## **PRODUCT BULLETIN #422**

Date: May 29, 2020

## **Subject: Axle Label Improvement**

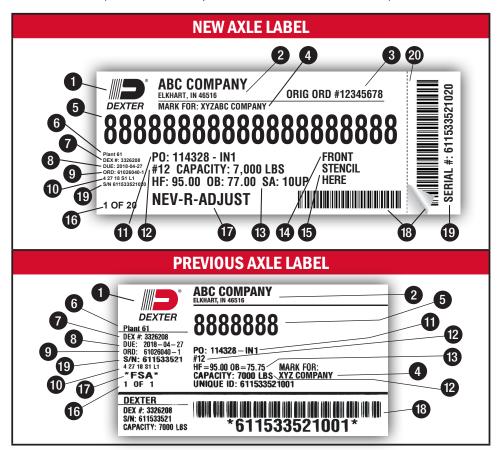
Dexter is pleased to announce a significant change to the design and size of identification labels utilized on Sprung and Torflex® axles. The new label design addresses several customer inputs regarding functionality and legibility, as well as improving adhesion and location. Each is valuable as Dexter seeks to improve the customer experience at a production facility or in the field.

- Length increase from 5" to 7"
- Serial number ticket move from the bottom to a 1" removable ticket on the end
- Customer part number increase from a 12 character to a 20 character limit
- "Mark for" or the customer "ship to" moves to the top of the label
- Feature call out increase in size and shift to the bottom center removes the need for an additional "Nev-R-Adjust®" label
- Location labels will be placed on the rear of the axle tube; positioned towards the frame mount
